## **HILLVIEW SUBDIVISION, FIRST ADDITION TO, RESUBDIVISION OF LOT 11**

APPLICATION NUMBER 3 DATE January 7, 2021  
 APPLICANT Hillview Subdivision, First Addition To, Resubdivision Of Lot 11  
 REQUEST Subdivision

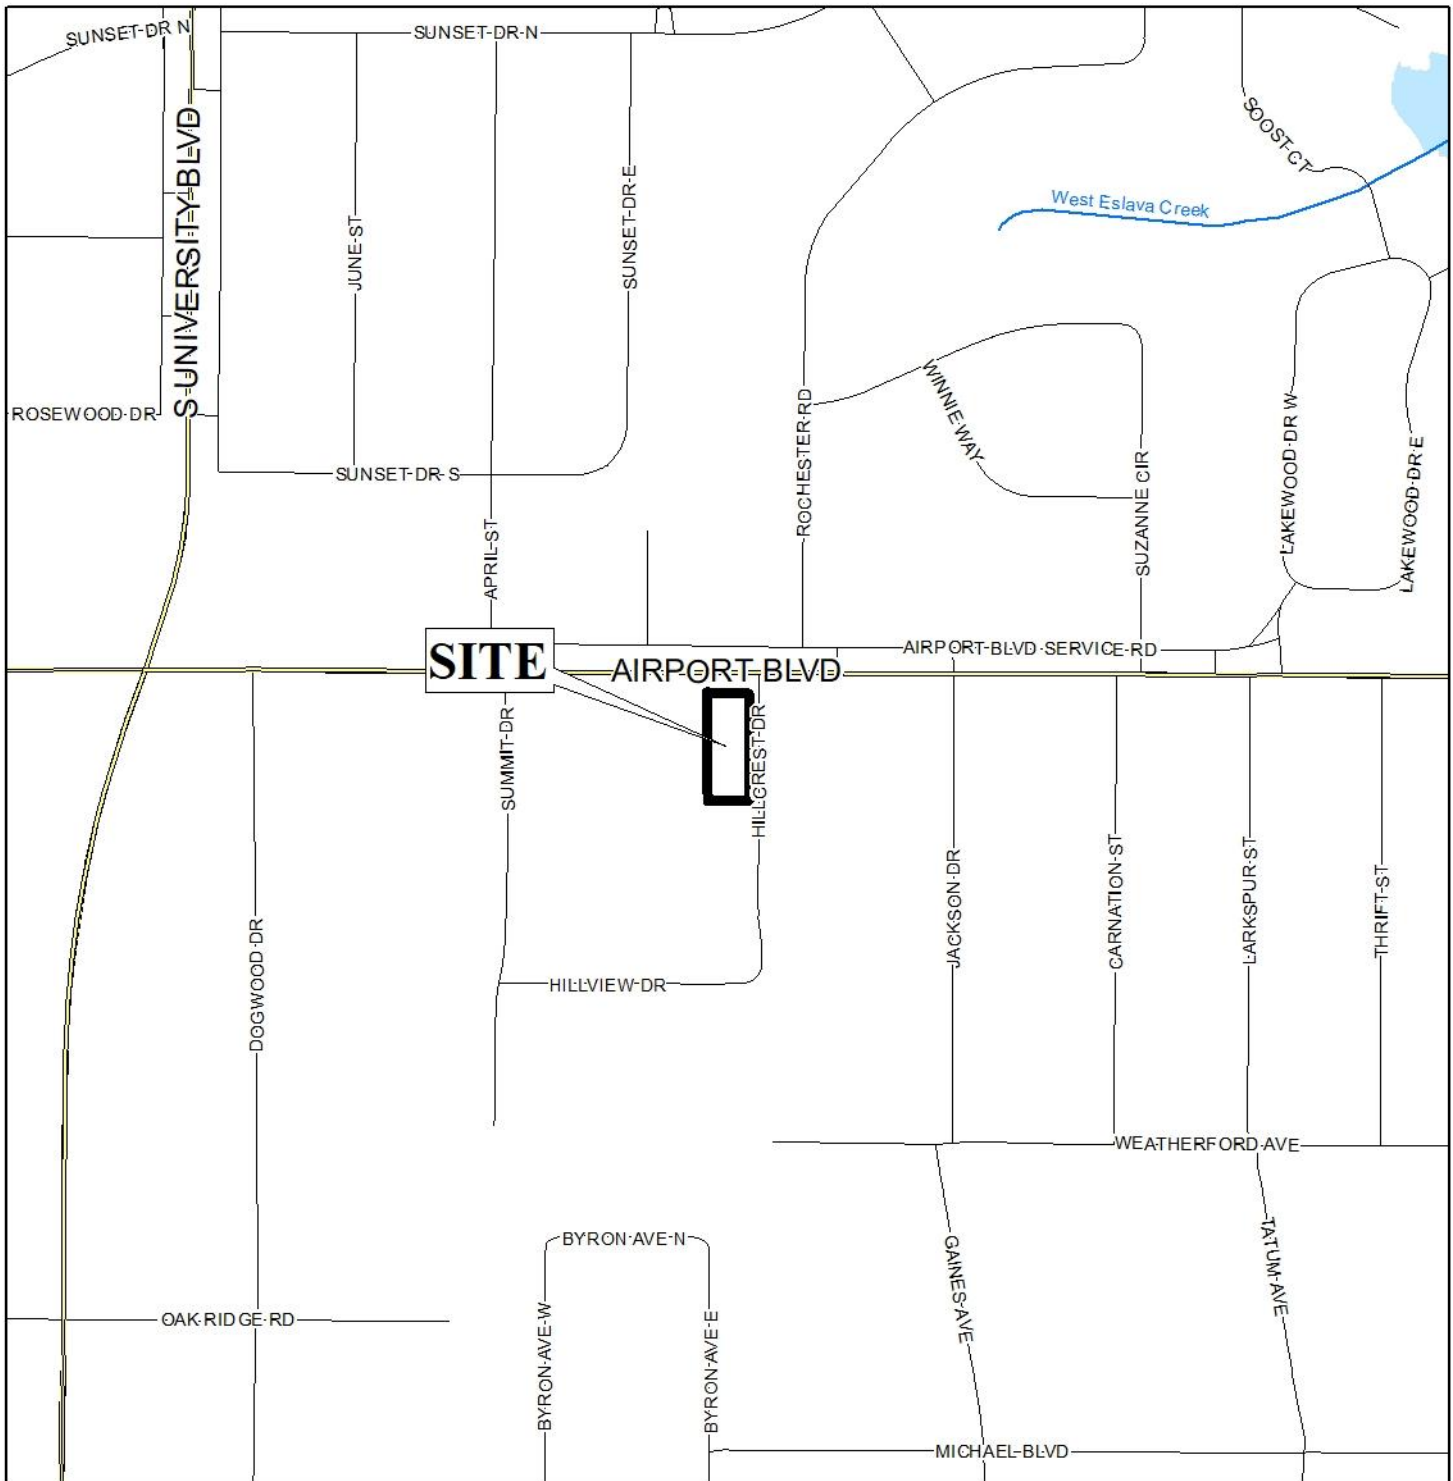
- B. Provide and label the monument set or found at the southwest corner of LOT 3.
- C. Provide the distance labels for the front and rear property lines of LOTS 1, 2, and 3.

- D. Dedicate the corner radius (25' minimum or as approved by the City Engineer and Traffic Engineer) at the northeast corner of LOT 1 to the City of Mobile, and list the amount of dedicated acreage.

Traffic Engineering Comments: Driveway number, size, location, and design to be approved by Traffic Engineering and conform to AASHTO standards. Lot 1 is denied access to Airport Boulevard.

The applicant proposes to create three lots, ranging in size from 9,782 to 9,800  $\pm$  square feet. Each lot will have 93 feet of frontage onto Hillcrest Drive, while proposed Lot 1 will additionally have 104 feet of frontage onto Airport Boulevard. All lots will meet the minimum width and area requirements of the Subdivision Regulations, however, the proposed lot sizes are much smaller than the other lots along Hillcrest Drive, which range from 19,000 to 29,000 square feet.

Due to the site's location, access management is a concern. As per Traffic Engineering comments, Lot 1 is denied access to Airport Boulevard. Additionally, the driveway number, size, location, and design are to be approved by Traffic Engineering and conform to AASHTO standards.

The 25-foot minimum building setback line, required by Section V.D.9. of the Subdivision Regulations, is depicted along all street frontages, and should be retained on the final plat, if approved.

A corner radius may be required at the intersection of Airport Boulevard and Hillcrest Drive, to comply with Section V.B.16. and V.D.6. of the Subdivision Regulations. The applicant should coordinate with the City Engineer to determine if a radius is required.

Finally, the existing structure on the site should be removed, with the appropriate permits, prior to the signing of the final plat. No permits for new vertical construction should be issued until the final plat has been recorded.

- 1) Removal of the existing structure, with the appropriate permits, prior to the signing of the final plat;
- 2) Coordination with the City Engineer to determine if the dedication of a corner radius is required in order to comply with Section V.B.16. and V.D.6. of the Subdivision Regulations;
- 3) Retention of the 25-foot setback along all street frontages;
- 4) Revision of the plat to reflect any changes to lot area if necessary due to right-of-way dedication for a corner radius;
- 5) Compliance with Traffic Engineering comments, and placement of the comments as a note on the final plat (*Driveway number, size, location, and design to be approved by Traffic*
